PUBLIC HEARING MEMORANDUM

SUBJECT: **Petition #449-22** for SPECIAL PERMIT/SITE PLAN APPROVAL to amend Special Permit #234-10 to extend a nonconforming use; to allow the construction of sport courts, a warming hut and associated parking; to determine appropriate dimensional requirements; to determine appropriate setbacks relative to parking; to waive perimeter screening; to waive interior landscaping; to waive lighting and to waive bike parking facilities at **1897 Washington Street**, Ward 4, Newton, on land known as Section 43 Block 46 Lot 11, containing approximately 2,291,142 sq. ft. of land in a district zoned SINGLE RESIDENCE 1. Ref: 7.3.3, 7.4, 3.4.1, 7.8.2.C.2, 3.1.2.A.3, 5.1.8.B.2, 5.1.13, 5.1.9.A, 5.1.9.B, 5.1.10.A, 5.1.11 of Chapter 30 of the City of Newton Rev Zoning Ord, 2017.

1897 Washington Street

ZONING REVIEW MEMORANDUM

Proposed structure elevations

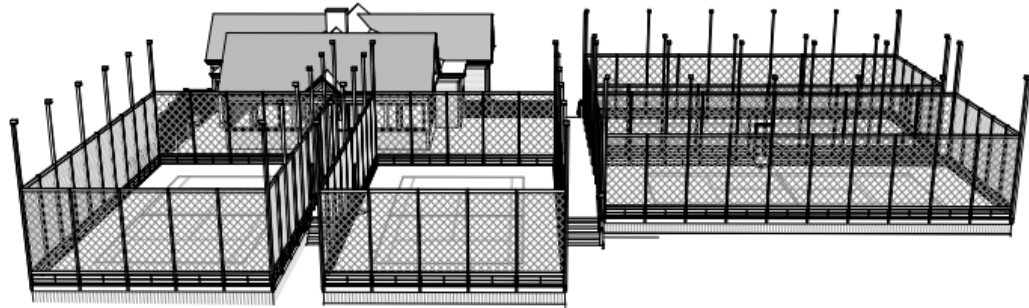
The petitioners are proposing to extend the existing nonconforming use with the construction of four paddle courts, a multi-use sport court, and a one story, approx. 15 feet high structure (the "warming hut") with restrooms, changing rooms and other sports facilities. The proposed structure and two courts are located approximately three feet from the abutting MBTA rail property. As the property across that corridor is also owned by the petitioner and operated as part of the Club, the Planning Department is generally not concerned with this placement.

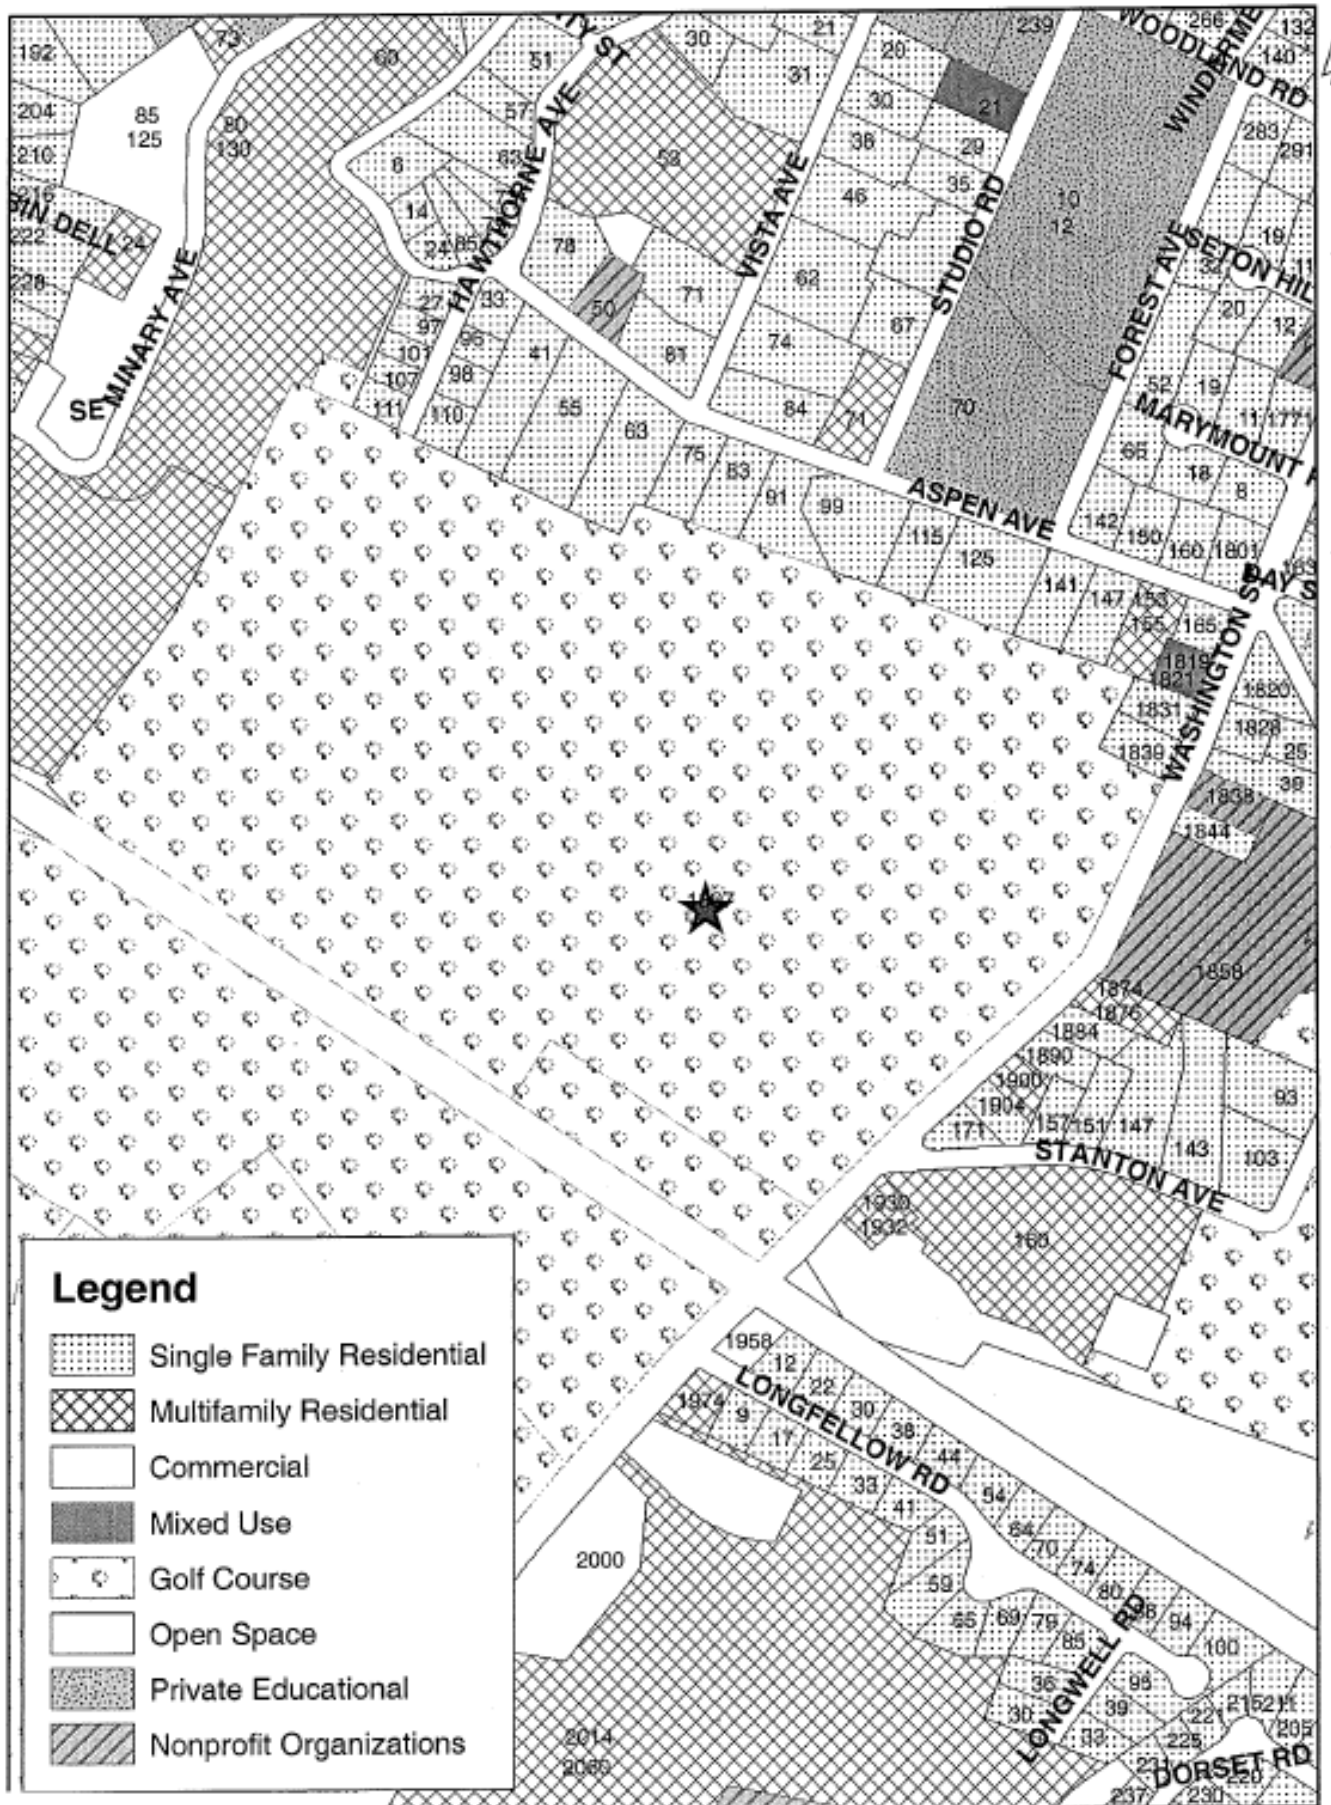
The petitioners are proposing to construct new access roads to connect the location of the proposed improvements with the existing main entrance driveway off Washington Street as well as another connecting the proposed parking area directly to Washington Street. The new roadways would measure 22 feet in width and provide access to 50 parking spaces to be located adjacent to the proposed facility improvements/additions. The proposed parking area would be located in an area now apparently used for the storage of maintenance vehicles. The Planning Department suggests that the petitioner be prepared to discuss how it expects to operate these two access roads, e.g., traffic flow direction(s), hours of operations, etc.

Generally, the stalls located along the periphery of the parking area are proposed to have nonconforming depths of 17 feet, rather than the NZO-required 19 feet. While the petitioner should endeavor where possible to provide conforming parking stall sizes, the Planning Department notes that such spaces would be utilized by club members who could reasonably be expected to become familiar with the facility.

As indicated in the submitted plans, the parking area would include several bicycle parking spaces. The petitioner should confirm the number of bicycle parking stalls so as to determine whether the requested relief from relevant requirements is needed at this time.
